From: [Teena Halbig](#)
To: [Mandell, Rachel](#)
Cc: [Engel, Robin](#); [Benson, Stuart](#); sheronlear@twc.com; rayehlers1@gmail.com; [Teena Halbig](#)
Subject: Re: 20-Waiver-0132 DRC Jan. 6, 2021
Date: Monday, January 4, 2021 2:46:32 PM
Attachments: [image006.png](#)
[image005.png](#)

Hello Ms. Mandell,
Why is the landscape buffer disappearance sought?
Is there other green space being given elsewhere on the plan?
Green space is needed in the Cedar Creek Watershed.
Sincerely,
Teena Halbig
FFEA Planning Chair
20-WAIVER-0132
Request:
Waiver of 10.2.4 to Not Provide a Landscape Buffer
Project Name:
Heine Brothers Waiver

Location:
7701 & 7703 Bardstown Rd
Owner:
Newton Enterprises, LLC
Applicant:
Lockett and Farley, Emily Estes
Jurisdiction:
Louisville Mero
Council District:
22 - Robin Engel
Case Manager:
Rachel Mandell, Planner I

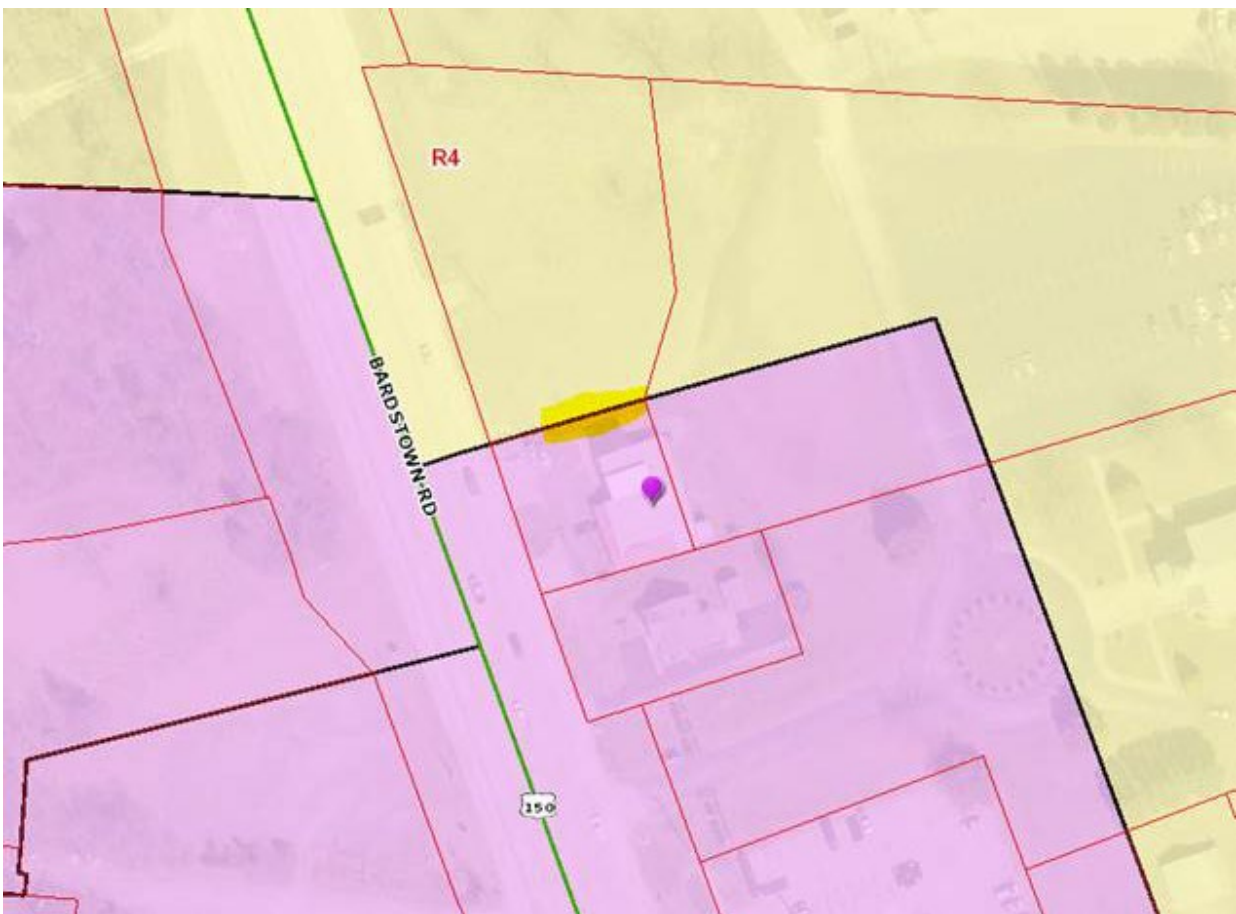
Concerns are for the watershed of Cedar Creek where the 25 foot landscape buffer area would help with water quantity and quality issues. Is there room for more trees and other plantings on the property? Did this get a landscape review?

If necessary, perhaps a downsizing of the Heine Bros. building would allow meeting the 25 foot buffer retention?

While no opposition of the Heine Bros use of the property, Floyds Fork Environmental Association wants to see **retention of the 25 foot buffer** in the Cedar Creek watershed (Cedar Creek is tributary to Floyds Fork Creek).

Between residential uses and commercial uses, there is a required 25ft landscape buffer between the two uses. The vacant lot to the North of the subject site is zoned residentially, therefore requiring a landscape buffer for the proposed Heine Brothers. I have highlighted on the photo below the location of the landscape waiver.
